## City of Mississauga Department Comments

File(s): A419.21 Ward 11

The applicant requests the Committee to approve a minor variance to allow the construction a gazebo proposing:

Property Address: 5140 Amana Place

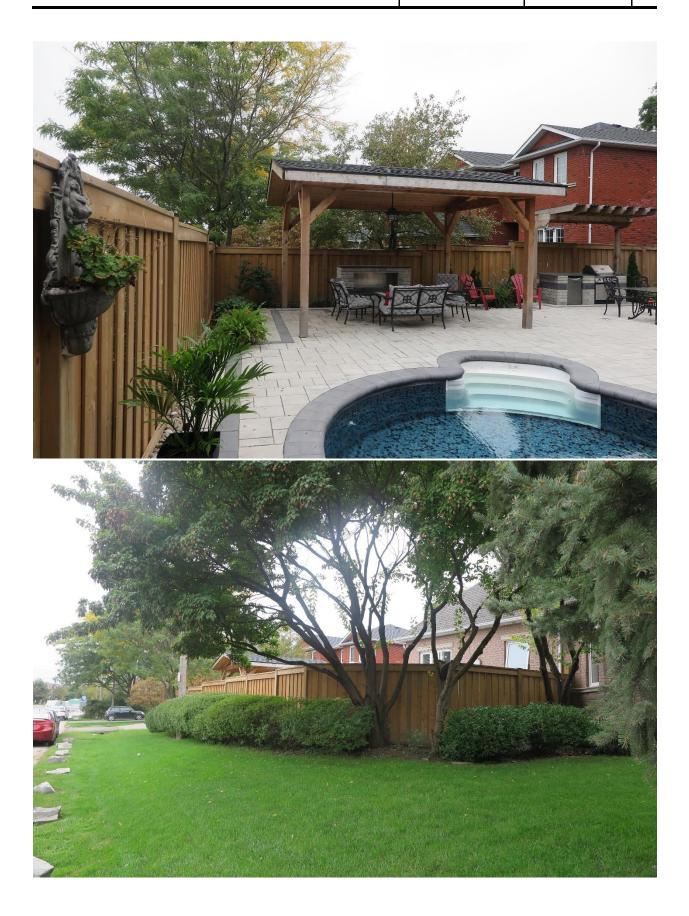
Enclosed for Committee's easy reference are photos depicting the existing gazebo as constructed. From our site inspection we note that this is a corner lot and the gazebo has been constructed in a location where any drainage from the roof can/will be directed towards the street ditch on Barbertown Road. It should also be noted that the existing gazebo could be equipped with an eavetrough and the downspout(s) located such that any drainage be directed towards the street ditch on Barbertown Road.
